Work Order ID 85377

DART SERVICE INSTRUCTION

TO AMEND INSTALLATION INSTRUCTIONS IIN-D412-698 REV. E OR LATER APPROVED REVISION
AND ICA-D412-698 REV. 5 OR LATER APPROVED REVISION

REF. TCCA STC: SH92-43
REF. FAA STC: SR01446NY
REF. EASA IM.R.S.00709

FIGURE 2: D3675-5/-6 BRACKET INSTALLATION ON COMPOSITE DOORS
(-6 SHOWN, -5 OPPOSITE)

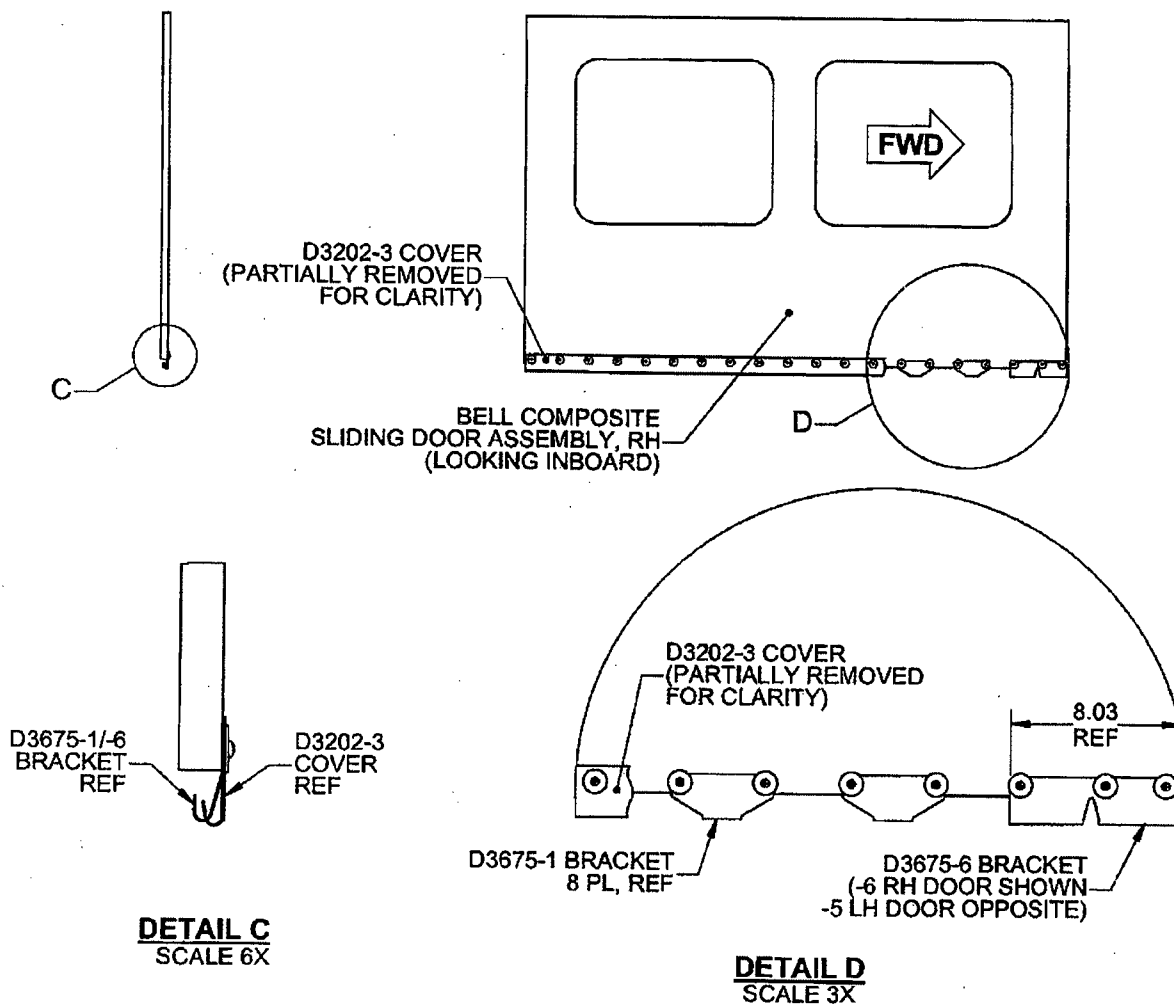
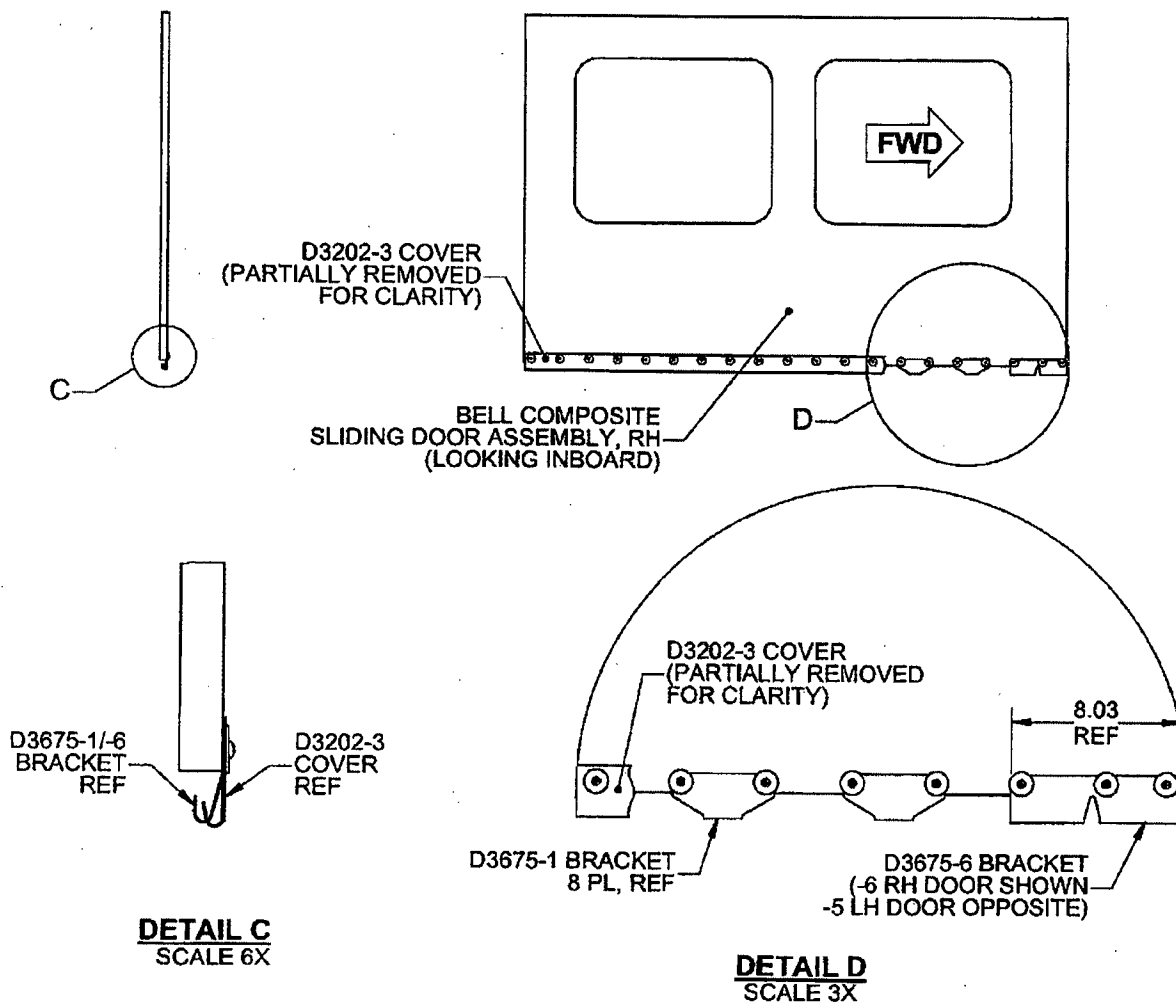
Field experience has shown that the forward D3199-1 brackets that are part of the D412-698-011/-012/-017 Cabin Door Roller Kits and forward D3675-1 brackets that are part of the D412-698-031/-032/-033 Cabin Door Roller Kits may wear prematurely if the aircraft is flown a significant amount of time with the sliding doors open. Dart has developed the D412-698-027/-028 kits that includes a longer D3199-3/-4 bracket for installation in the first forward position of the D412-698-011/-012/-017 kits to reduce wear on these forward brackets on aircraft equipped with aluminum doors. Likewise, Dart has developed the D412-698-037/-038 kits that includes a longer D3675-5/-6 bracket for installation in the first forward position of the D412-698-031/-032/-033 kits to reduce wear on these forward brackets on aircraft equipped with composite doors.

- 1) Remove the sliding door from the aircraft per Section 52.1 of ICA-D412-698
- 2) Remove the first forward D3199-1 or D3675-1 brackets as applicable.
- 3) Install the D3199-3/-4 or D3675-5/-6 bracket as applicable in lieu of the removed -1 bracket. Refer to Figure 1 Sheet 2 (aluminum doors) or Figure 2 Sheet 3 (composite doors).
- 4) Torque hardware per ICA-D412-698.
- 5) Re-install sliding door on aircraft per Section 52.2/52.3 of ICA-D412-698 as applicable.
- 6) Make entry in technical records of aircraft indicating that DSI 9484 has been completed.
